# PHASE 2 (PRE-COVER) PROPERTY INSPECTION REPORT

REPORT # SM XX-0816P2P

A SINGLE FAMILY RESIDENCE AT  
**XXXXX WRENWOOD WAY, HOUSTON, TX 770XX**

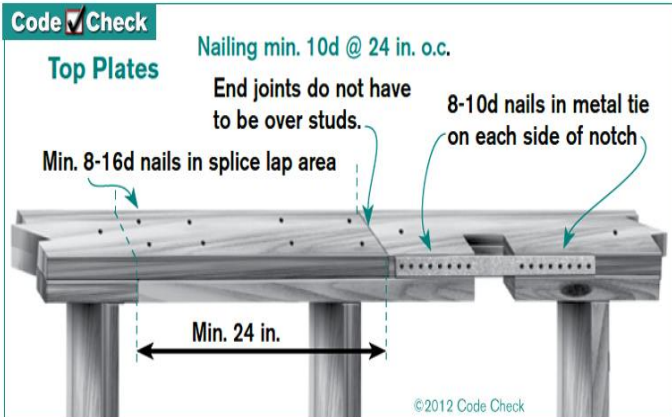
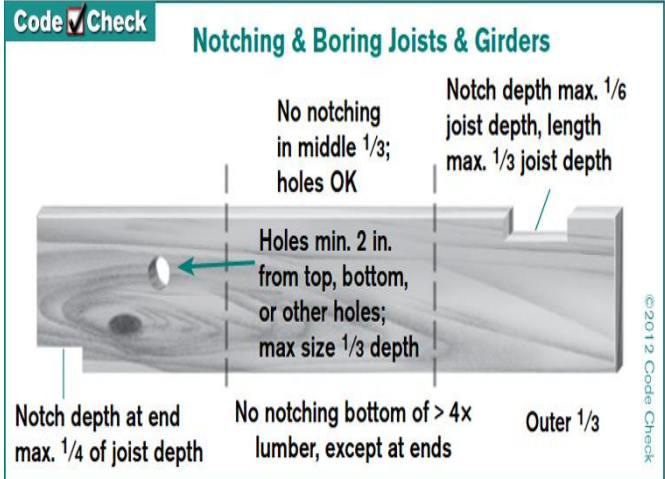
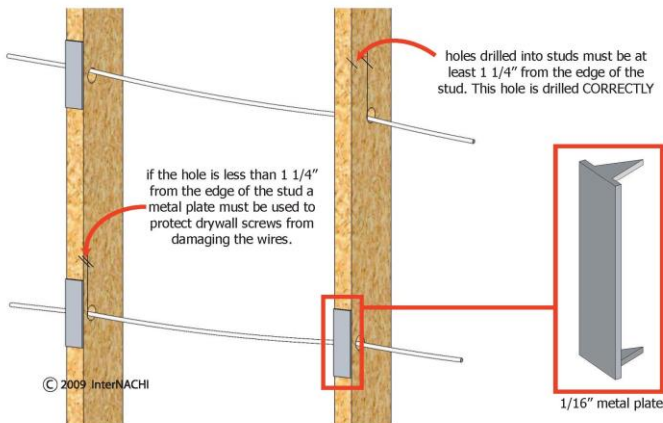
1. Missing anchor bolts in required locations. Anchor bolts were not installed within one foot from sill plate ends, from corners &/or doorways. Such locations marked on nearby lumber. See photos below. Foundation should be checked thoroughly and anchor bolts should be installed within one foot from sill plate ends & not less than 7 dia. of anchor bolts, from corners &/or doorways in such locations. A minimum of 2 anchor bolts are required per sill plate. 1/2" dia. x 10" long expansion bolts may be used where conventional anchor bolts are required. Such locations were marked on lumber. See first row of photos.
2. Missing 2"x2"x1/8" washers on anchor bolts required in wind prone areas.
3. Missing washers on some anchor bolts.
4. Round washers and nuts were over tightened and biting into bottom plates and thus reducing the load carrying capacity of base plates. See second row of photos.
